# Axiom Hub

## Version: V1.0.7

### Release Note

### (2020-10-30)

**4) Support Illegal Card Event Upload**

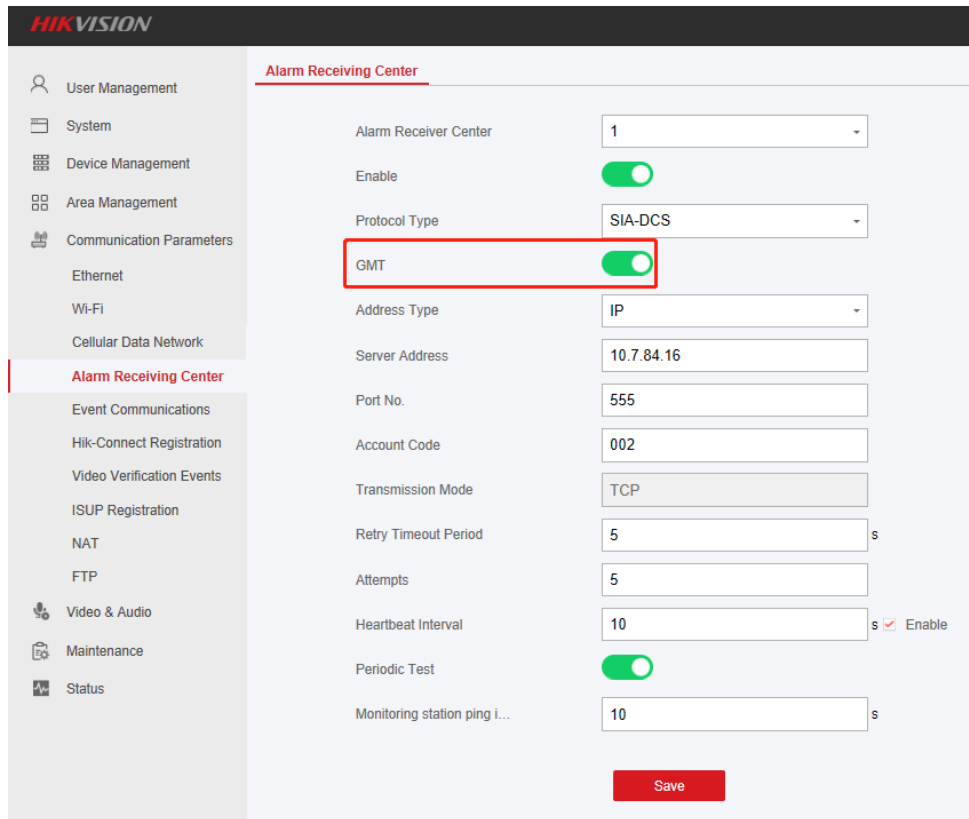
After unregistered cards swiped, panel will record logs and push messages. Add CID Event---illegal card operations Event. Support APP, ISUP protocol, 4200 shows illegal card operation, the detailed parameter will show card number.

### 1) Cellular Data Usage Optimization

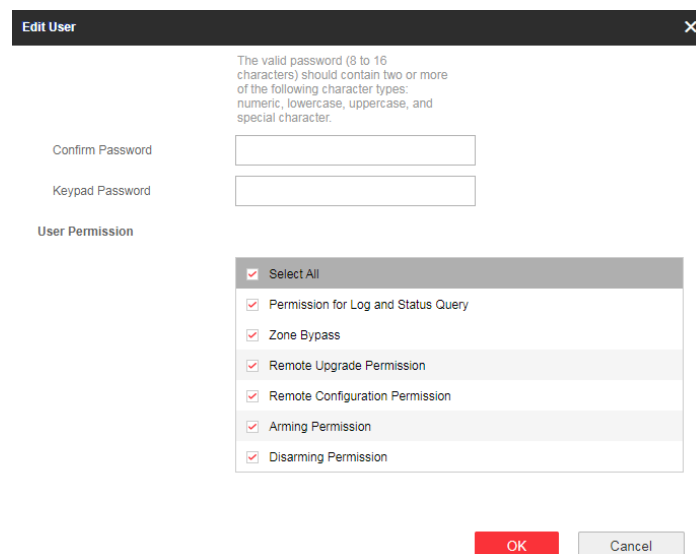
Optimized Cellular Date usage, in normal use scenarios where there is no video uploading, no email sending and other large data uploads, the monthly Cellular Data usage drops to less than 40M..
